DS-K1T344 Series MinMoe Terminal
Release Notes (2025-07-30)

Device Model: DS-K1T344MX-E1, DS-K1T344MBWX-E1, DS-K1T344MBWX-QRE1, DS-K1T344MBFWX-E1 DS-K1T344MFX-E1 DS-K1T344EX-E1 DS-K1T344EBWX-E1 DS-K1T344EBWX-QRE1 DS-K1T344EBFWX-E1 **Naming Rule:** M for M1 card, E for EM card -E1 for POE, B for Bluetooth F for Fingerprint, W for Wi-Fi -QR for QR code reader	Firmware Version	ACS_344_F2pro_EN_STD_V4.47.0_build250722 ACS_344_F2pro_EN_NEU_V4.47.0_build250722
	Software	**HikCentral Access Control:** https://www.hikvision.com/en/support/download/software/hikcentral-access-control-v2-3-1/ **Please add device to HCP/HC AC with port 80, and port 8000 will not work**

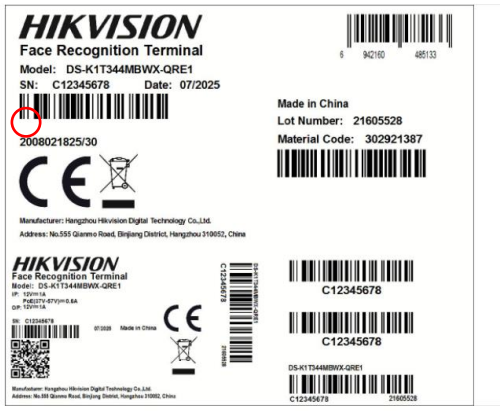
Upgrade RAM from 256MB to 512MB, and the label of 512MB models contains a letter "T"

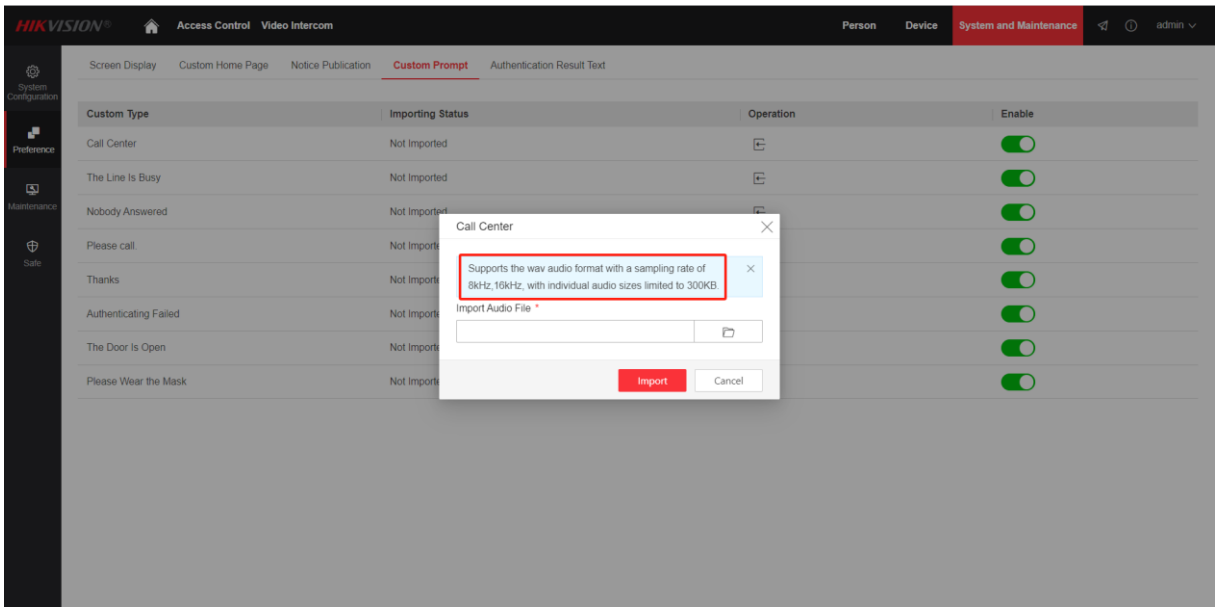
2. After call and unlock from the indoor station with # key, indoor station will send room number to

door station, and door station will upload the “remote unlock” events with the room number to 3rd party platform.

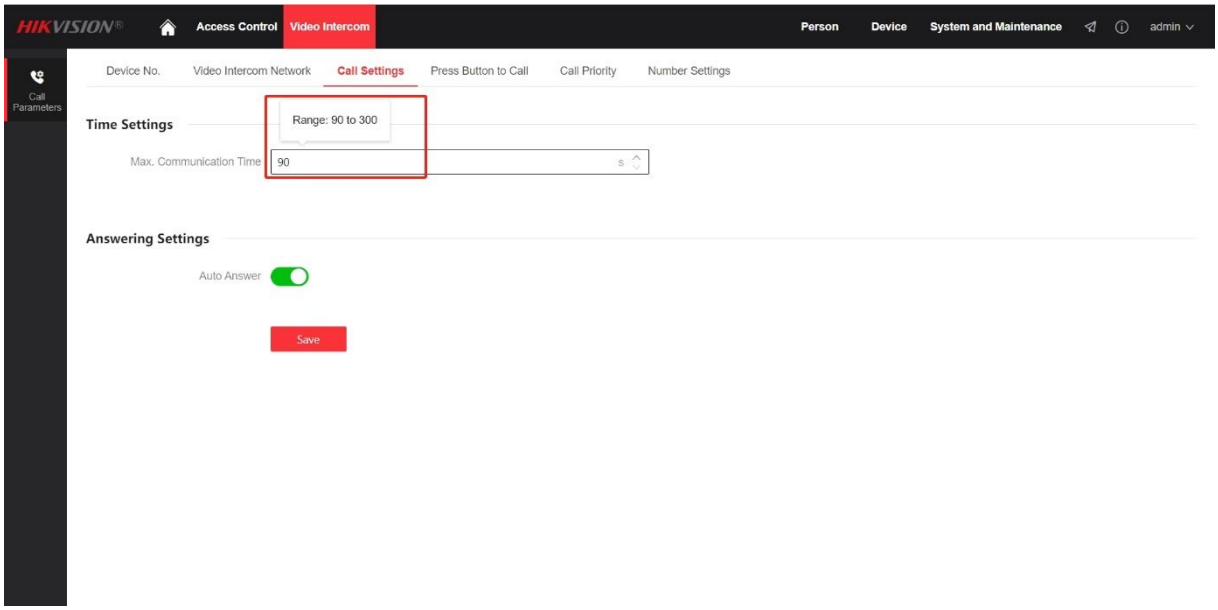
5. Adjust the sub stream resolution to 320*240 to decrease the video quality when using intercom function in low bandwidth network.

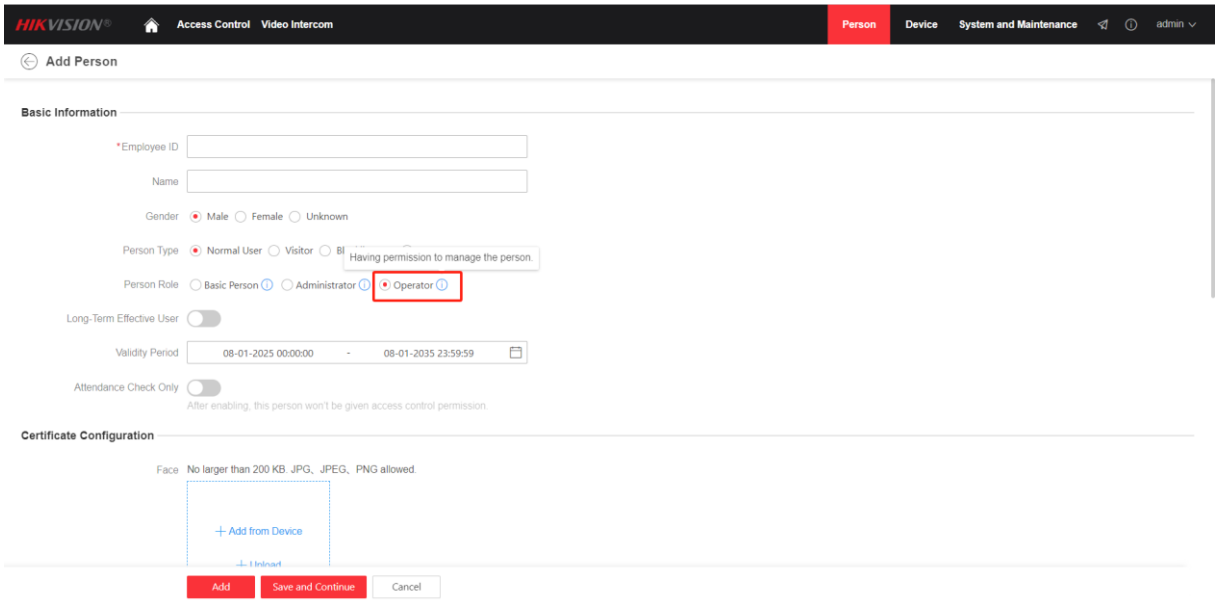
6. When import the audio file in web page, it will check the sampling rate, audio channel numbers, and size automatically.
7. Increasing the maximum intercom duration to 5min (was 90s before), the range is from 90 to 300s and by default it's 90s

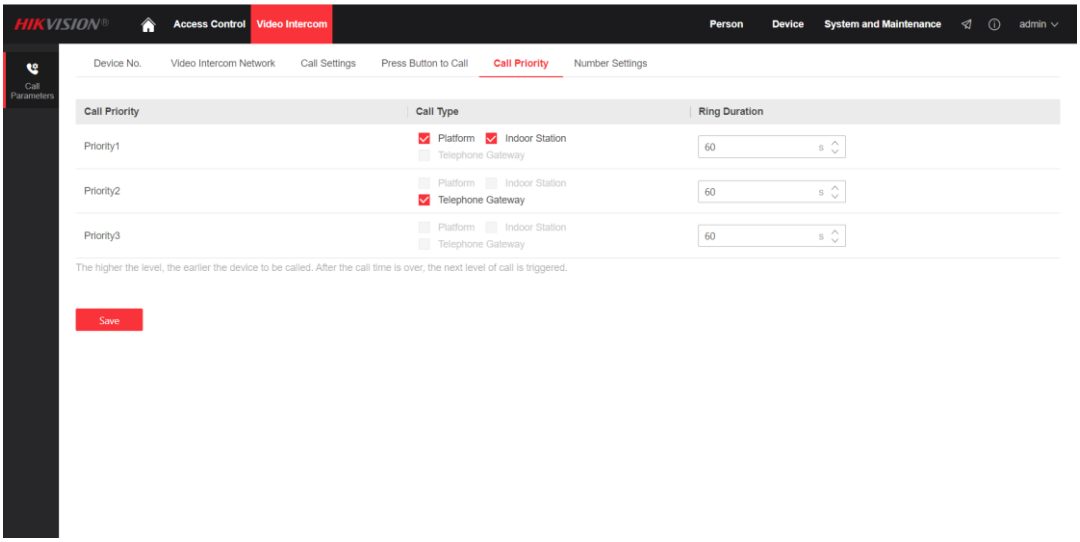
8. Adding operator roles, the operator has the permission to enter the local menu on the screen and manage the personnel on the device.

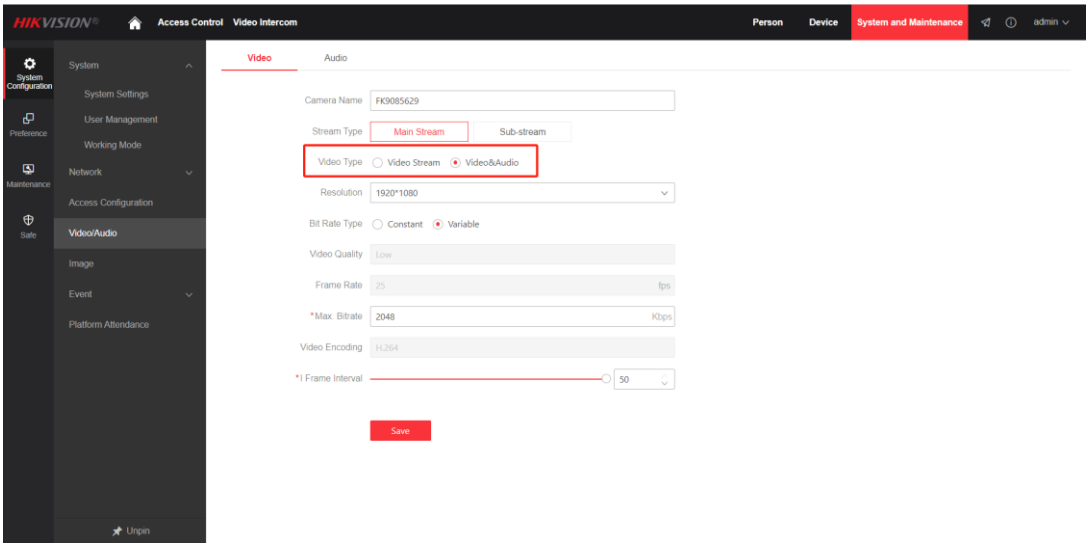
9. Support calling priority settings on web page

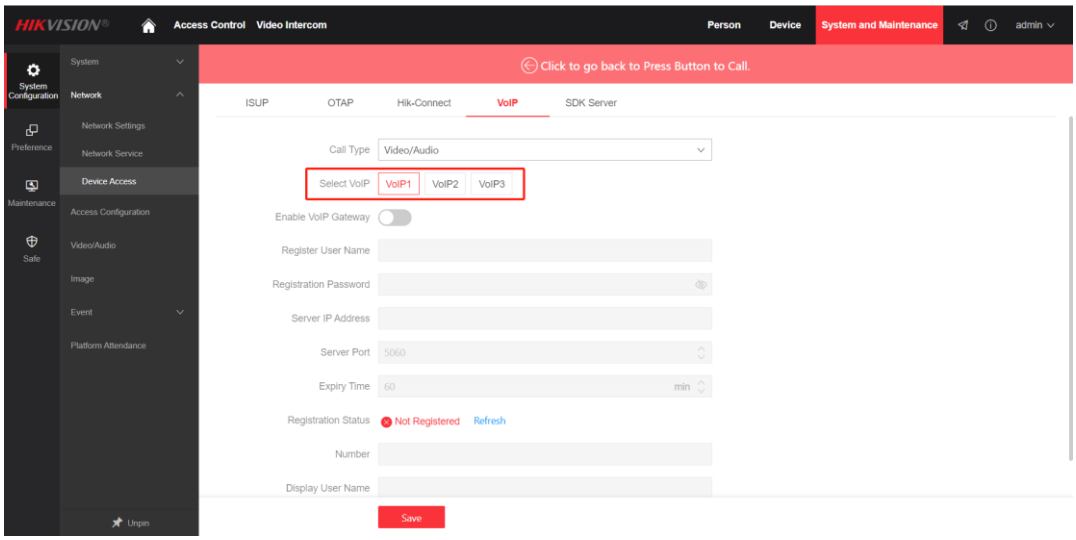
10. Support both **audio only** and **audio & video** when working in standard SIP protocol

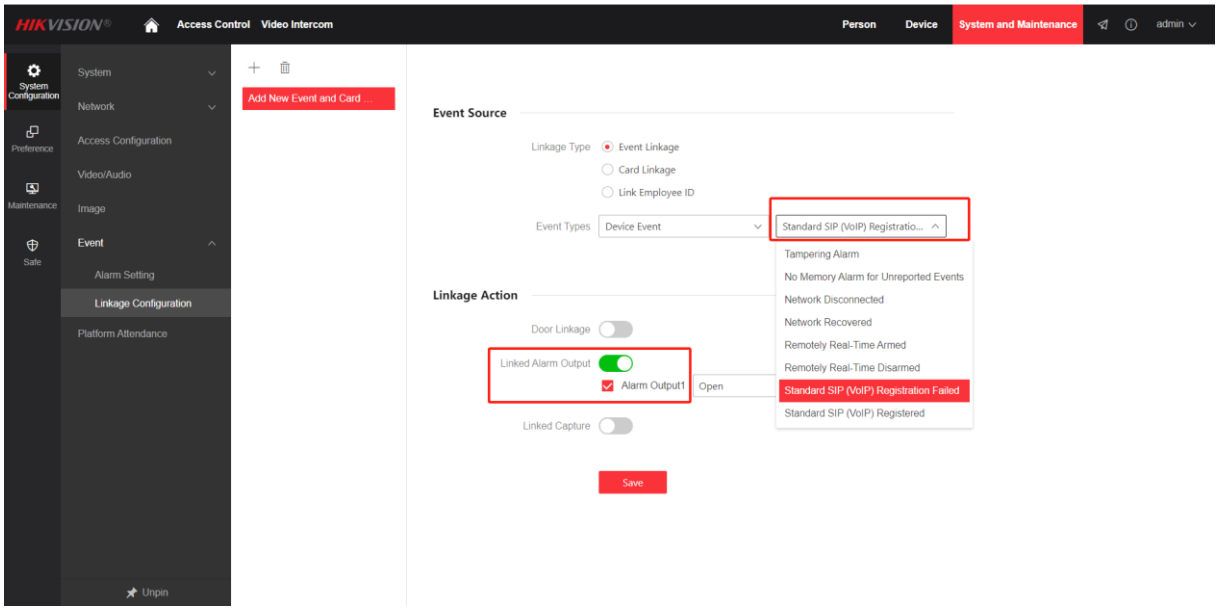
11. Support up to 3 SIP servers connection and administrators can back up the SIP server parameters.

12. Support to manage SIP servers on K1T344 web page only, and check SIP servers' information on K1T344 local screen page.

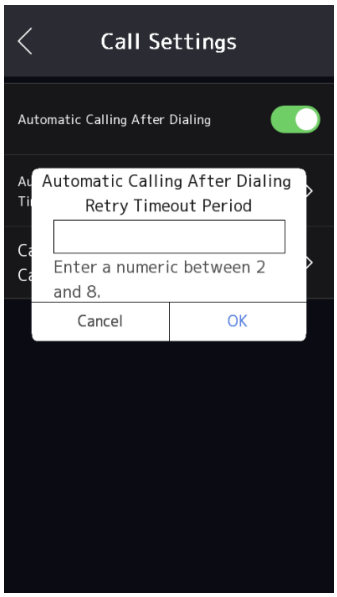
13. Support automatically register after administrators switch SIP server parameters, and trigger alarm out if failed to register

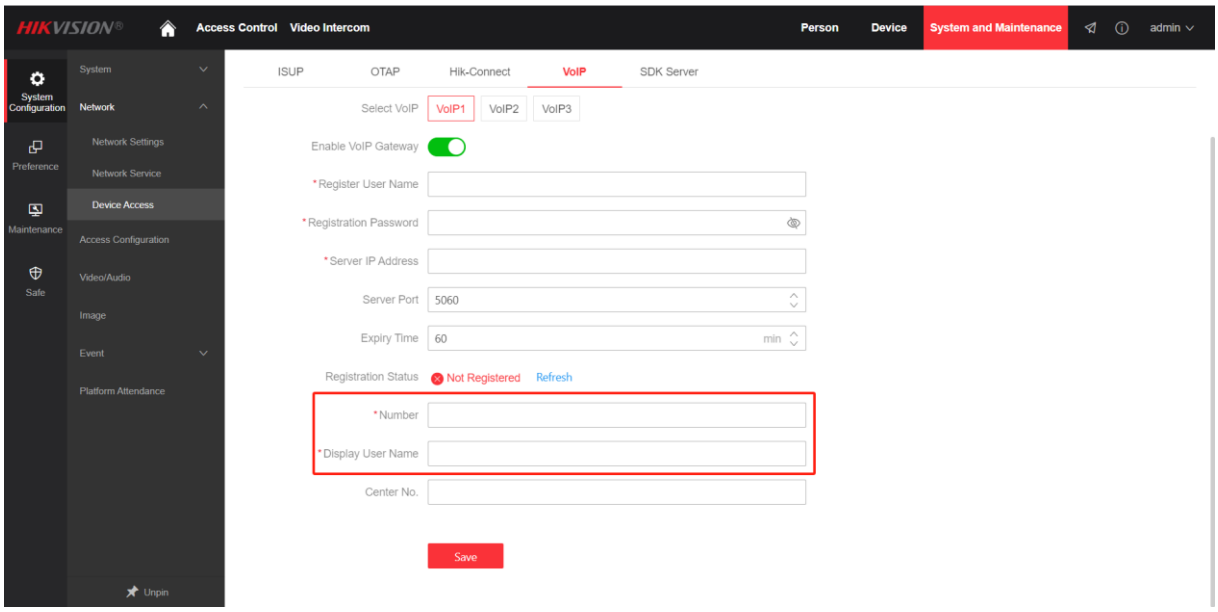
16. Support configure VoIP central SIP number
    a) Administrator are allowed to configure central SIP number of SIP server in KIT344 web page
    b) Adding a new central SIP number shortcut key in K1T344 local UI, supporting customization of whether to display it in the live view page

c) support one-click call to the center by clicking the SIP number shortcut key in K1T344 local UI. The call number is SIP number of the currently selected back-up server.

d) Users are allowed to call management center in K1T344 dialing page, supporting call management center and central SIP number

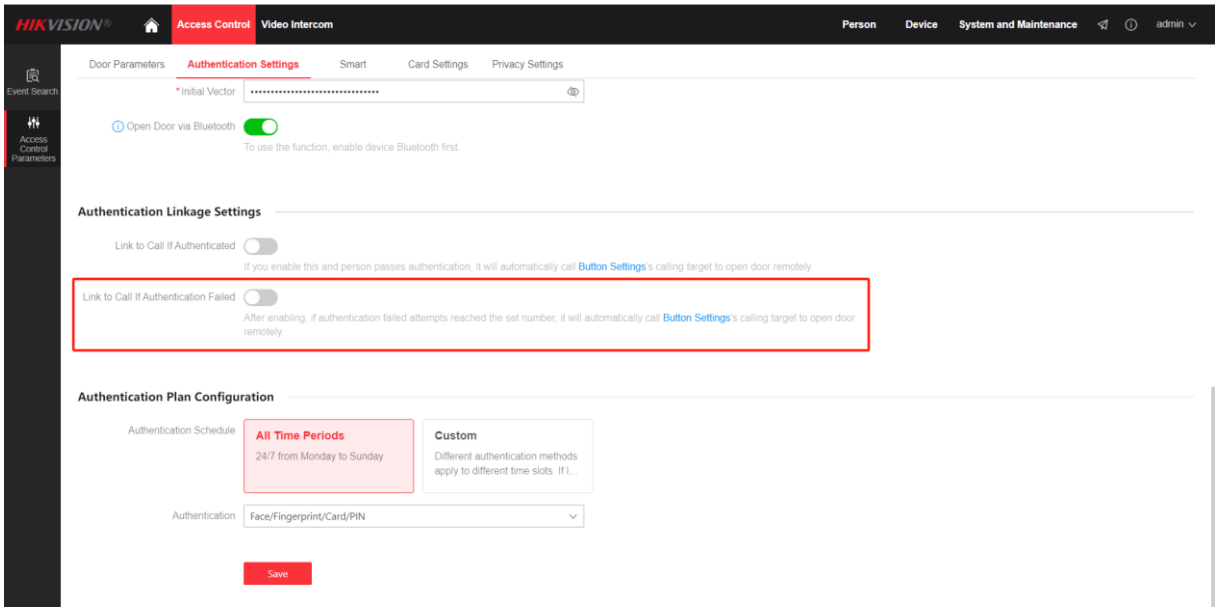
17. Support authentication failed linkage with calling:

a) Administrators are allowed to configure after how many times of failed authentications, the linkage will be triggered

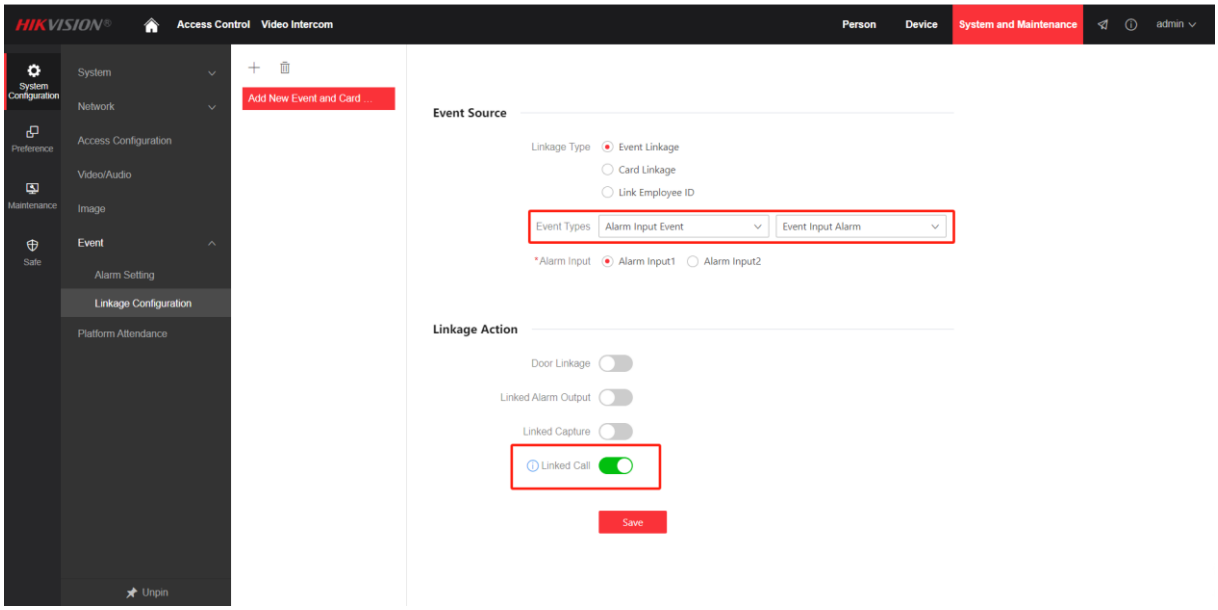
18. Support upload door contact events (door abnormally open, door close timeout) to Ezviz cloud

servers.

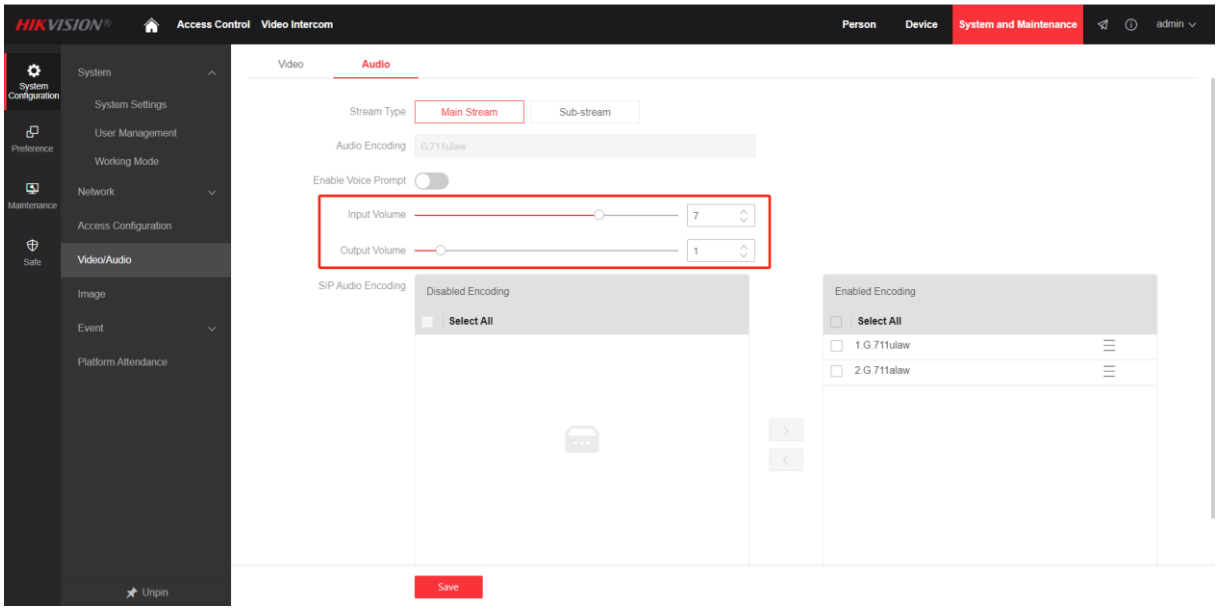
19. Support alarm input linkage with calling center:
    a) Support alarm input signal to trigger linkage with calling center
    b) Support external buttons signal input to trigger linkage with calling center

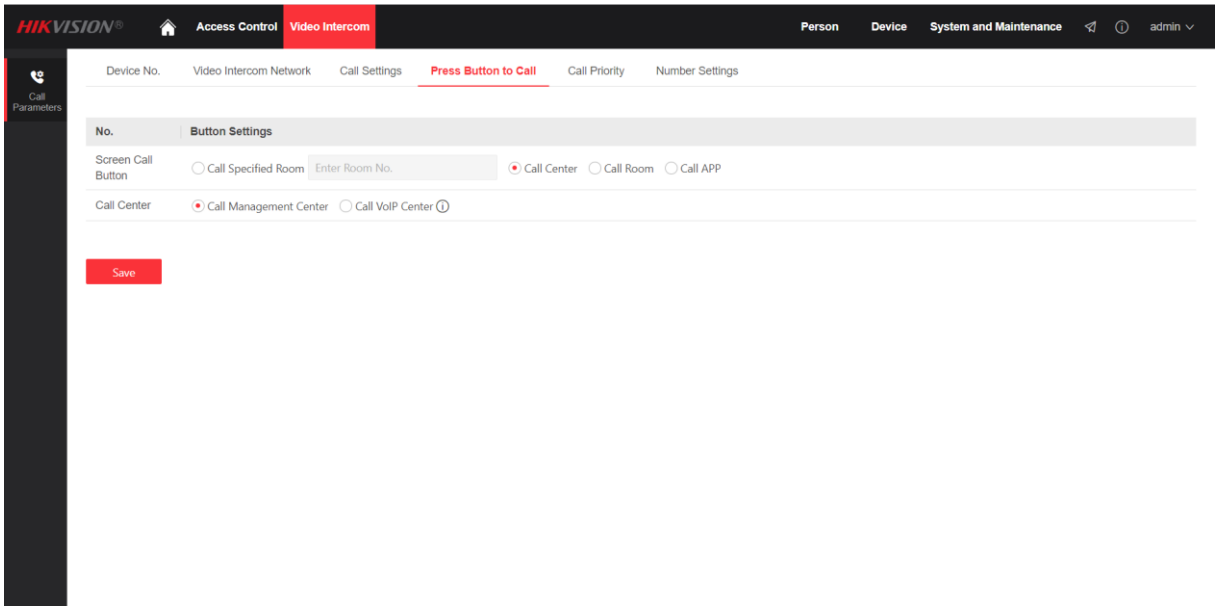
20. Support configure enable volume settings of customization prompts in web page

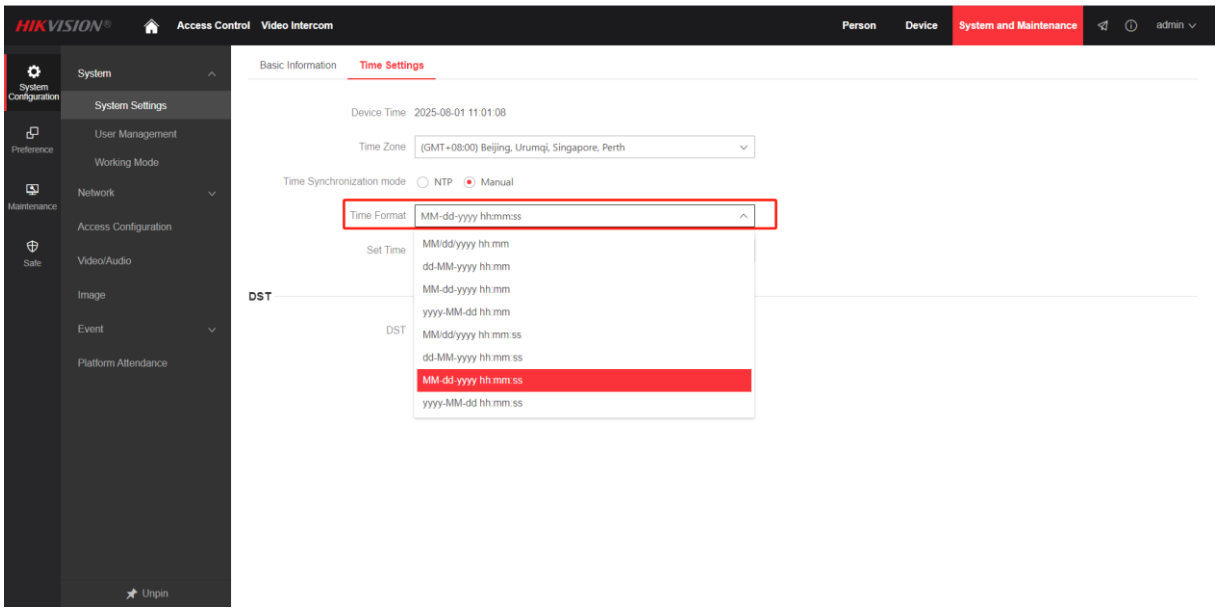
21. Support call VoIP center by one-click physical button

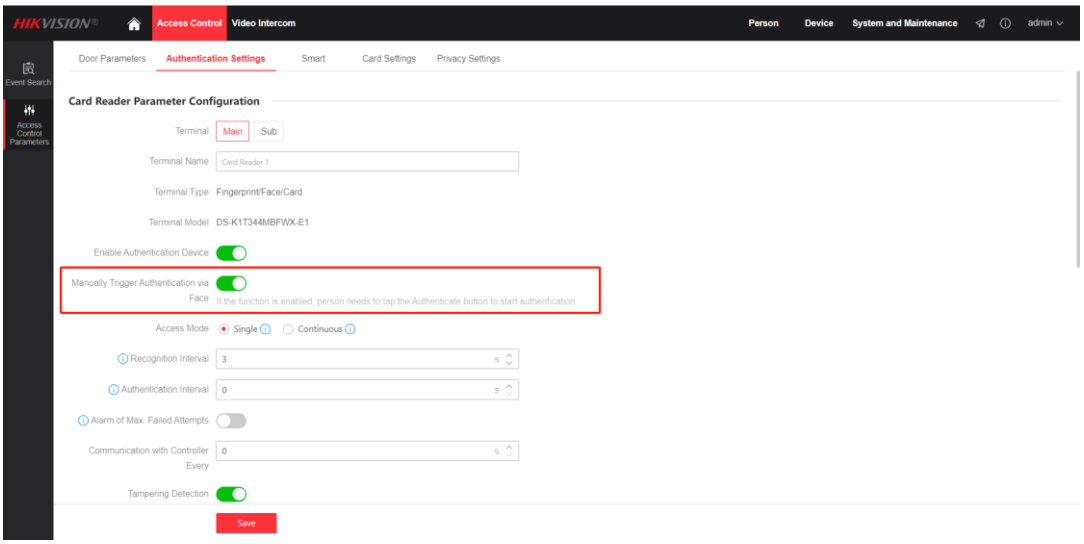
22. Support configure time format in web page, after configuration, the new time format will be sync to web page and local UI automatically
